LiDAR Quality Assurance (QA) Report
Eastern Shore Virginia (ESVA) LiDAR Project
USGS
November 18, 2011

Submitted to:
USGS

Contract:
G10PC00013

Prepared by:
 **Dewberry**

Figure 5-Tile LAS_S23_3853_20, Delivery 1. Ground density model showing an area of aggressive classification along the coast.

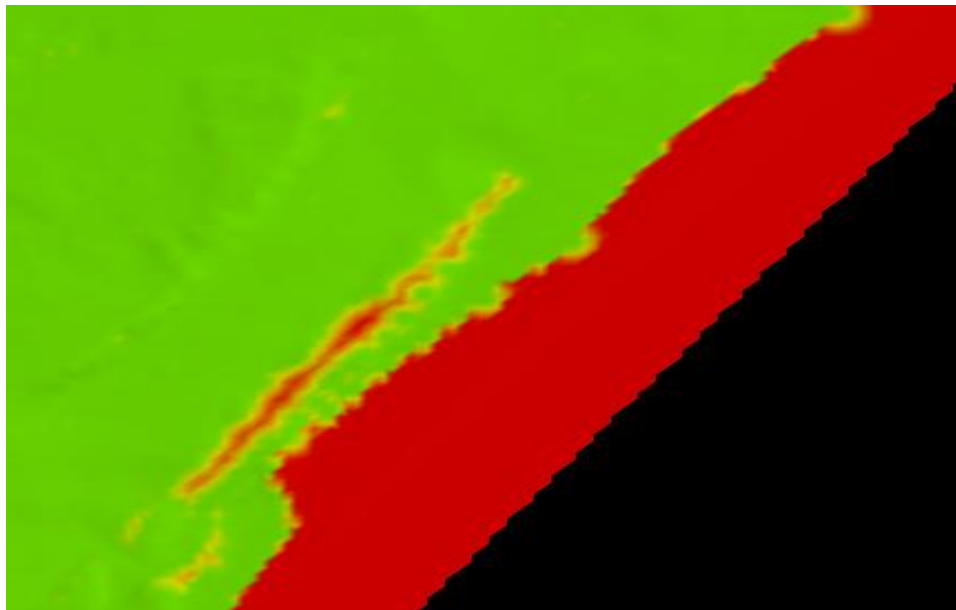
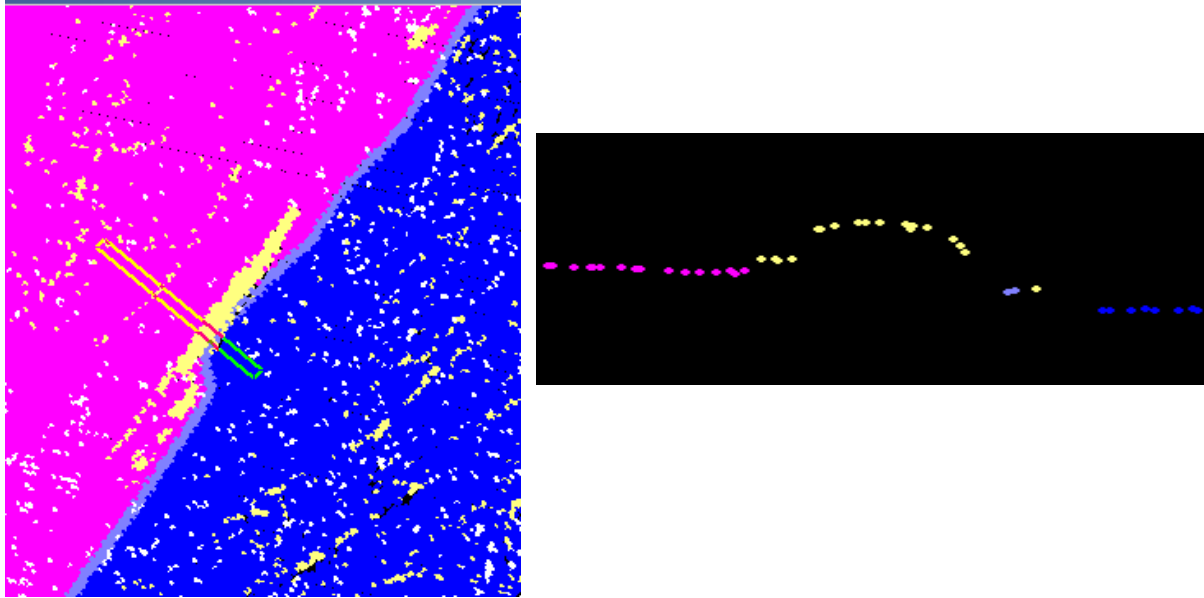
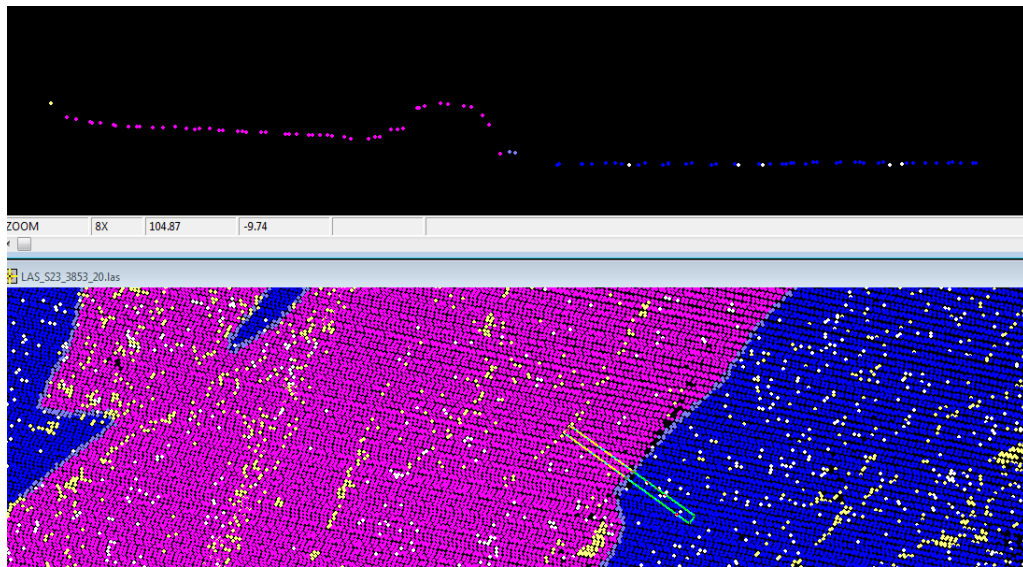
The first review of the Eastern Shore of Virginia LiDAR dataset identified multiple areas of aggressive classification. Most of the areas of aggressive classification occurred where legitimate ground points on a slope, such as along the bank of a hydrographic feature or a road embankment, were removed from ground and resulted in the loss of ground definition. Sanborn addressed all edit calls that impacted the final bare earth surface. Edit calls for aggressive classification that were minor and did not impact the final bare earth surface may not have been corrected or modified. Examples from the first and last deliveries are shown below.

Figure 6-Tile LAS_S23_3853_20, Delivery 1. Profile view of an area along the coast that was aggressively classified. An embankment was missing from the ground surface because these points had been incorrectly classified as class 1 (unclassified, yellow) but should have been classified as class 2 (ground, pink).

Figure 7-Tile LAS_S23_3853_20, Delivery 4. Profile view of an area along the coast that was aggressively classified, but has been corrected. Points representing an embankment had previously been classified as class 1 (yellow) but are now classified as class 2, ground (pink). This correction has added detail to the ground model.

Figure 8-Tile LAS_S23_2786_40, Delivery 1. Ground density model showing a void was present in the bare earth surface model. As the profile below shows, this void was a result of ground points being misclassified as class 1, unclassified.

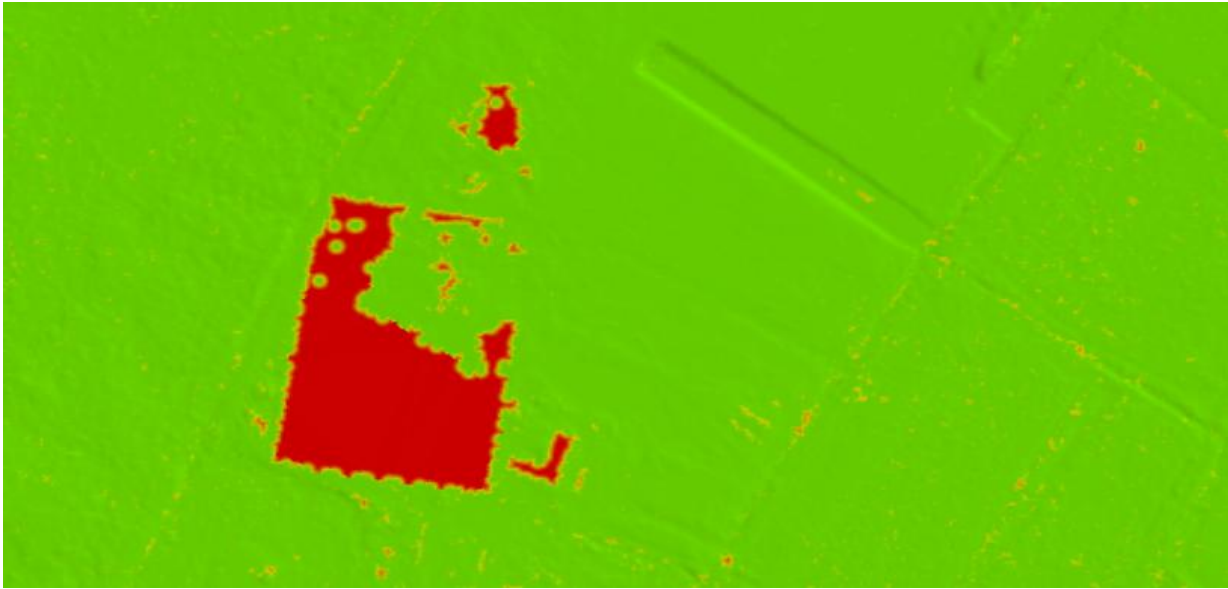
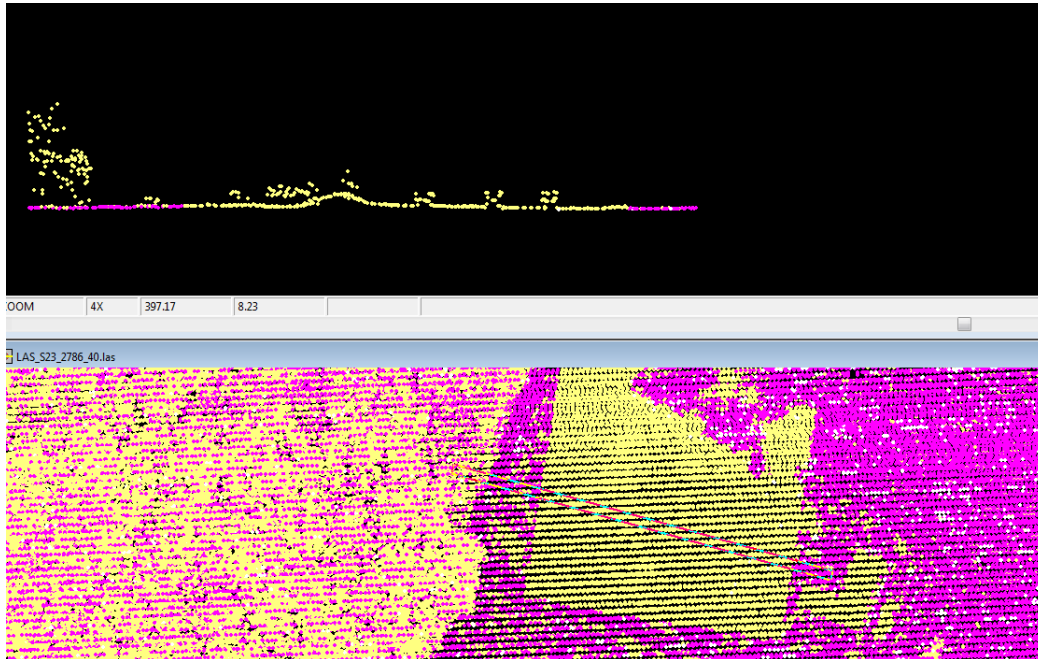
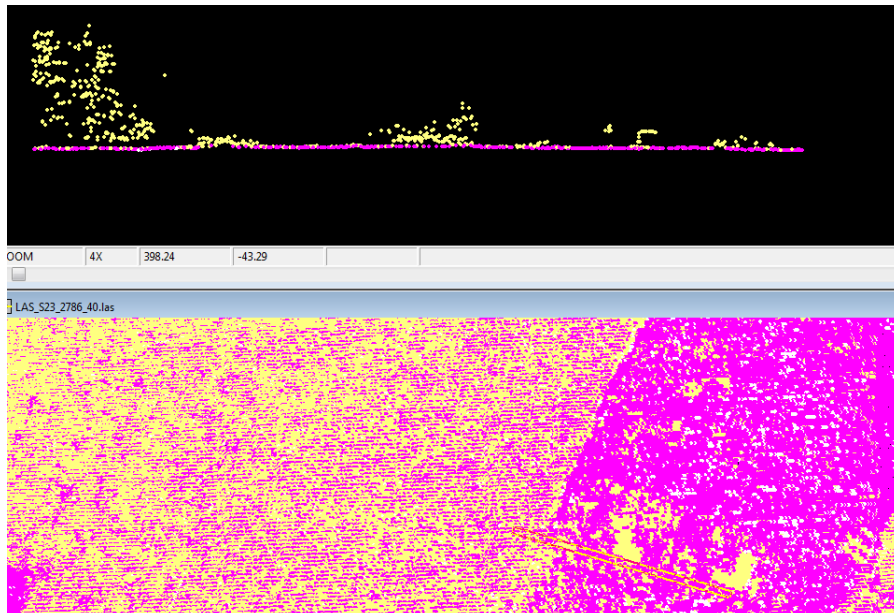
The first review highlighted multiple areas where ground points (class 2, pink) were misclassified to unclassified (class 1, yellow) or ground points were misclassified to water (class 9, blue). Sanborn addressed all edit calls that impacted the final bare earth surface. Edit calls for misclassification that were minor and did not impact the final bare earth surface may not have been corrected or modified. Examples from the first and last deliveries are shown below.

Figure 9-Tile LAS_S23_2786_40, Delivery 1. Profile view of points displayed by classification, showing points that were classified as unclassified (class 1, yellow) should have been classified as Bare Earth (class 2, Pink).

Figure 10-Tile LAS_S23_2786_40, Delivery 4. Profile view of points displayed by classification, showing legitimate points that were classified as unclassified (class 1, yellow) have been corrected by Sanborn and are now classified as Bare Earth (class 2, Pink).

Figure 11-Tile LAS_S23_2653_30, all deliveries. The ground density model is predominantly green meaning there is sufficient coverage of ground points and does not affect the quality of the ground model.

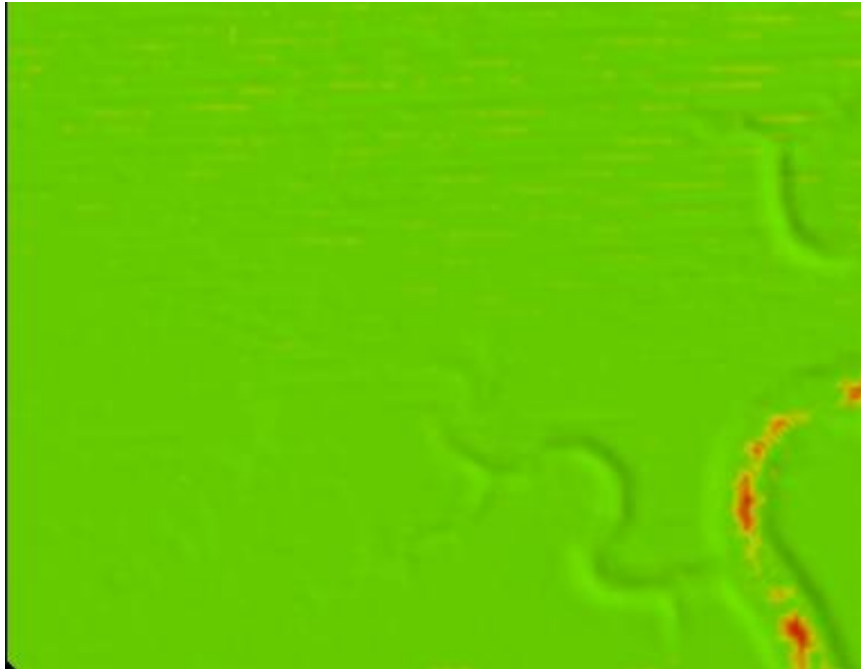
Dewberry identified several areas in the dataset with slightly uneven point spacing. The adjacent flight lines appear to diverge and converge, usually due to sudden changes in atmospheric conditions such as wind. This point spreading is somewhat visible in the density models. This issue does not affect the usability of the data but should be noted by the end user.

Figure 12-Tile LAS_S23_2653_30, all deliveries. The image shows the distribution of the points is not even, which causes the low density stripes in the density model.

Figure 13, all deliveries-Tidal breaklines are shown in purple, overlaid on the vcr_land_area" shapefile that identifies the extent of land that is used as a boundary for the USGS ESVA project. As the screenshot shows, tidal breaklines run through the middle of islands and appear unnatural.

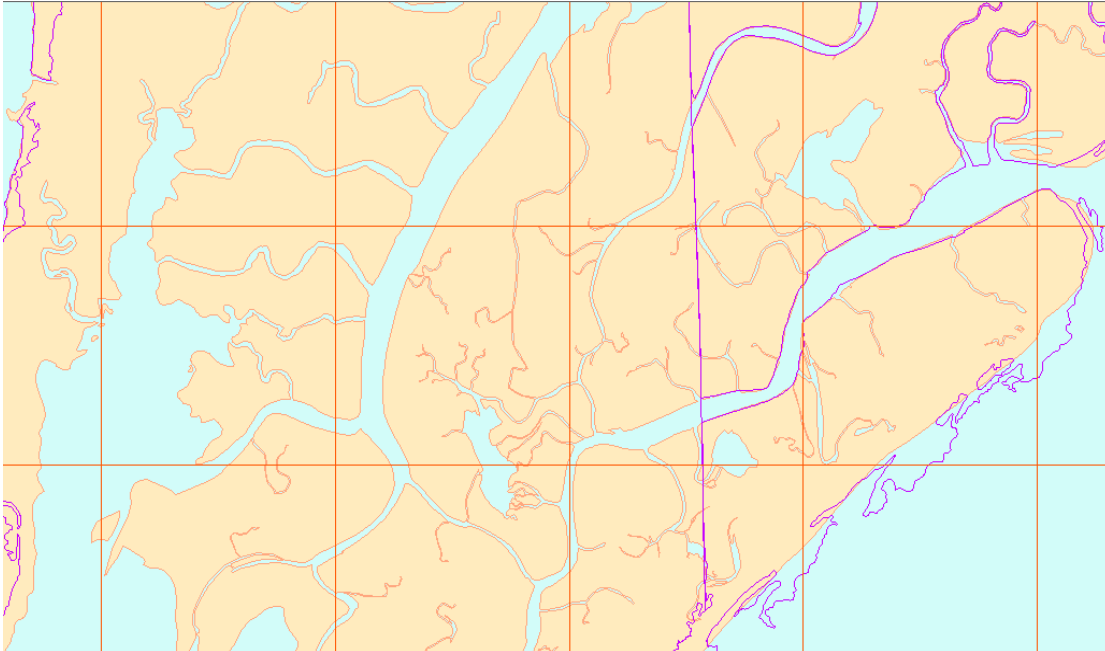
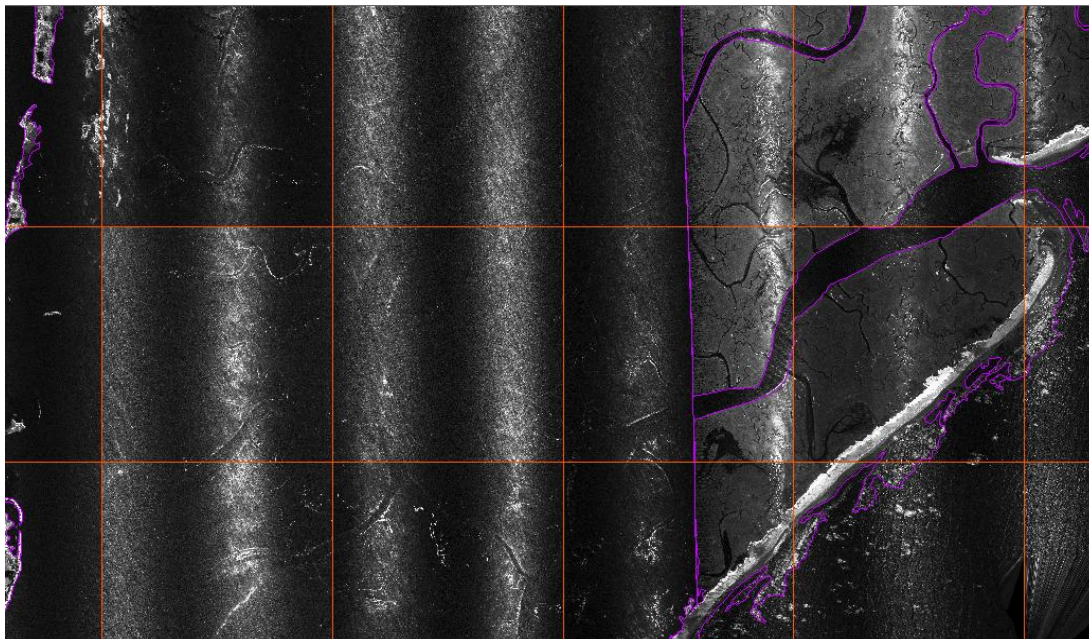
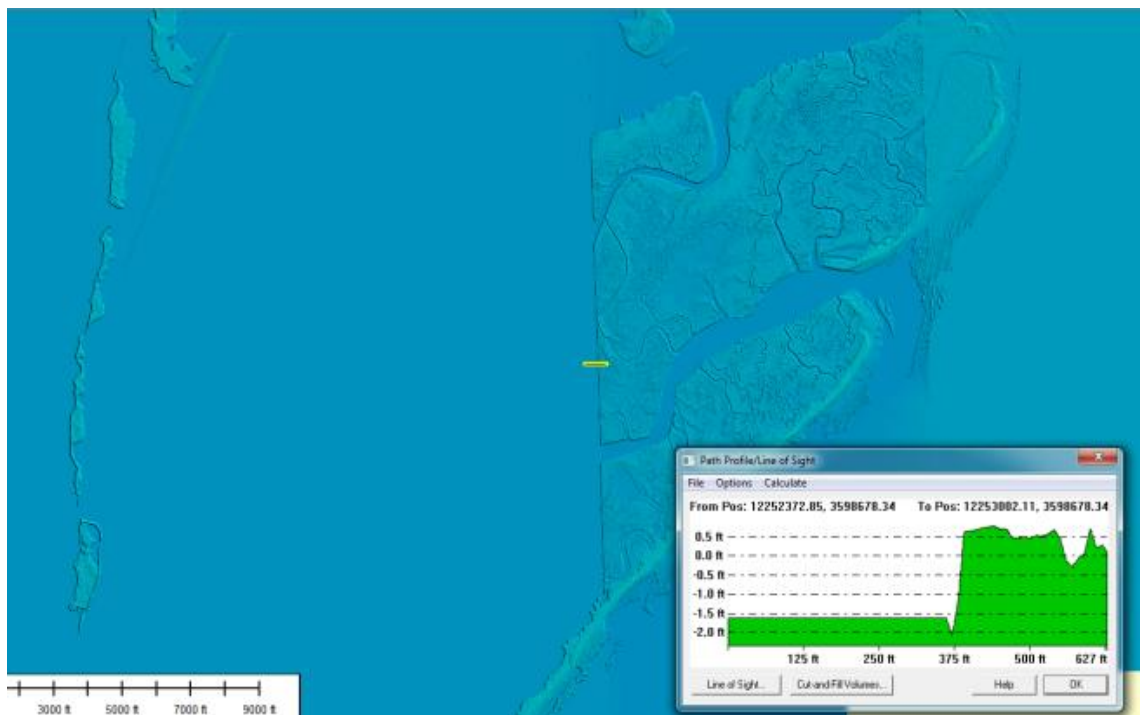
The entire coastline of this project area, which consisted of Accomack and Northhampton Counties, is tidally influenced. Differing tide levels can cause elevation changes within one flight line and can cause substantial elevation changes between flight lines. There are many low-lying islands off the coast of Accomack and Northhampton Counties. Many of these islands are only exposed at low tide. This caused some discontinuity in the data from one flight line to the next when an island is exposed in one flight line but inundated in the neighboring flight line.

This resulted in tidal breaklines that show abrupt changes between land and water interfaces. These breaklines often do not appear natural. However, this phenomenon is related to tidal fluctuations as Sanborn was not required to collect data at low tide.

Figure 14, all deliveries-Tidal breaklines are shown in purple overlaid on intensity imagery. As the screenshot shows, the tidal breaklines follow the land water interface as seen in the intensity imagery.

Figure 15, all deliveries-Tile LAS_S23_2559_20. Point cloud displayed by flight line source id. Flight line edges correspond to the land water interface seen in the intensity imagery and reflected in the breakline collection.

Figure 16, all deliveries-DEMs of the same area shown in the screenshots above. DEMs also seem to show an “unnatural” break between land and water interfaces due to large tidal variations between flight lines. While the water on the left side of this image is actually higher than the exposed island on the right side of this image, the water must be flattened and given a lower elevation. Otherwise, the water will appear as floating above surrounding land.

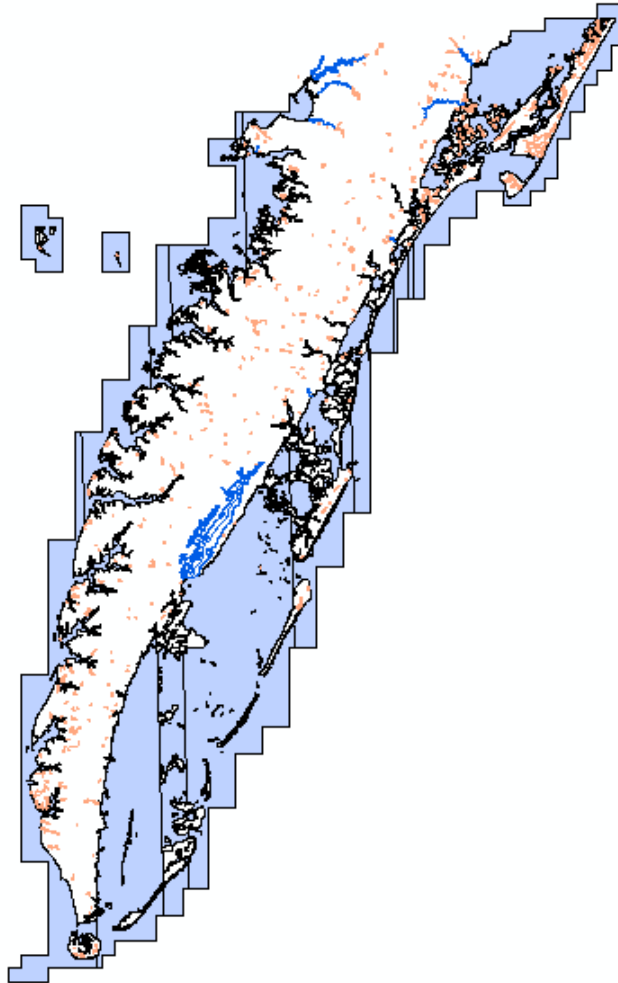
Normally, Dewberry asks that adjacent polygons be merged together into one feature. This is normally more organized and creates a cleaner line for the breakline data. However, due to tidal variations between adjoining flight lines, Sanborn has kept each tidal water area within a flight line as a separate polygon. Having Tidal Waters as separate polygons for each flight line helped immensely during the QA review as this area can be complicated, especially with tidal variations that can be drastic from one flight line to the next. Due to the usefulness of the separate polygons, Dewberry did not mark edit calls for “unnecessary polygon boundaries” in the Tidal Waters as is listed in the Breakline QA/QC Checklist. Below is a screenshot of the Tidal Water breaklines that are split at flight line boundaries.

Figure 17, all deliveries-Tidal Water polygon breaklines are shown in light blue with a black outline. Normally Dewberry uses the PLTS “unnecessary polygon boundaries” check to identify adjacent polygons that should be merged into one. Due to the drastic tidal variations between flight lines, having the Tidal Waters split at those boundaries was very useful during the QA review. Because it could be useful for end users to have the Tidal Water breaklines split at flight line boundaries, Dewberry did not run the unnecessary polygon boundaries check on Tidal Waters.

Figure 18-Tile S23_4900_40, Delivery 1. Island was not collected that is large enough to meet USGS specifications.

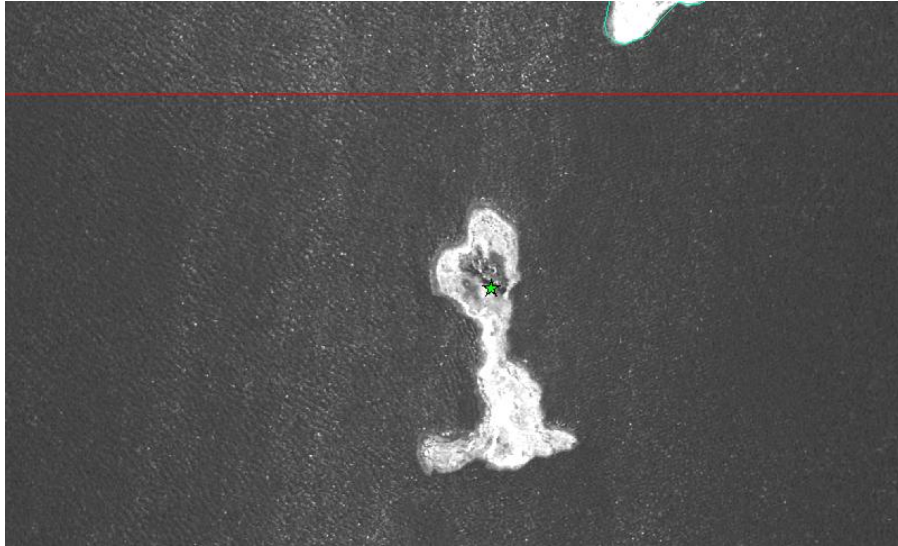
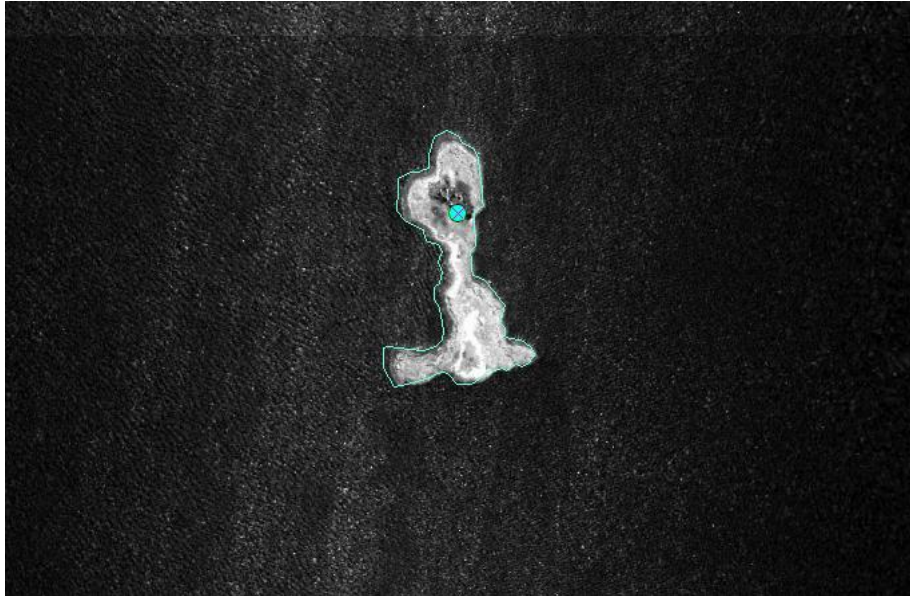
Islands that meet USGS capture specifications of .5 acres should be collected as “holes” and excluded from polygon layers, such as Inland Ponds and Lakes or Tidal Waters. Forty-eight (48) features were identified as missing in the first delivery. Sanborn has addressed these edit calls. An example is shown below.

Figure 19-Tile S23_4900_40, Delivery 4. Island has been collected.

Figure 20-Tile S23_4900_40, Delivery 4. Island has been collected and is now visible in the DEM.
